SERVICE LETTER

No. 631A

Alternator Switch and Circuit Breaker Panel Wiring Inspection

PA-31 and PA-31-300 Navajo

Service Letter 631A

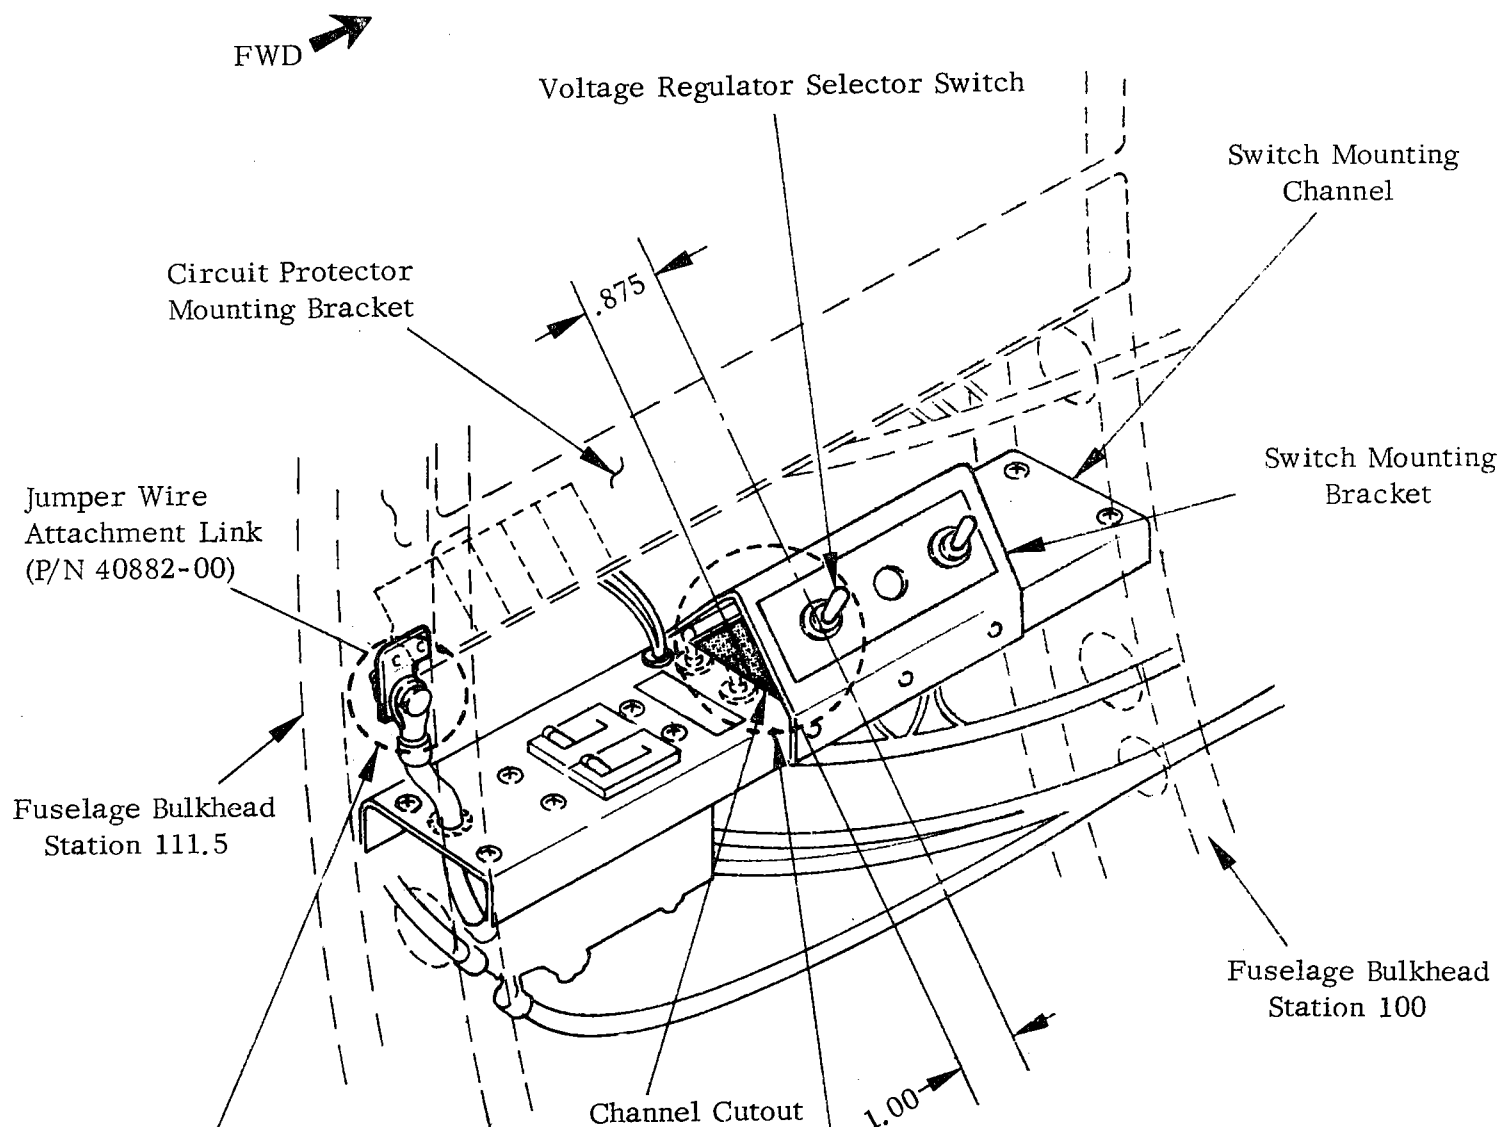
Inspect to make certain that the jumper wire attachment link is installed. Inspect jumper wire attachment hardware to assure that only AN4-4A Bolt and MS20365-428C Nut are used to attach the jumper wire to the link. The torque of hardware must be of sufficient tension to provide a tight electrical connection.

Inspect to make certain there is a distance of 1 inch between the edge of the switch mounting bracket and the center of the voltage regulator selector switch. If the 1 inch distance has not been maintained, enlarge the channel cutout to obtain a distance of .875 between the center of the voltage regulator selector switch and the edge of the channel cutout.

1. Inspect jumper wire attachment hardware for proper installation;
2. Insure that a proper distance of one inch exists between the edge of the switch mounting bracket and the center of the voltage regulator selector switch; and
3. Insure proper installation of Part No. 40882-00 Battery Attachment Link.

4. If the Part No. 40882-00 Battery Attachment Link is not installed as shown on the attached sketch/instruction sheet, install accordingly.
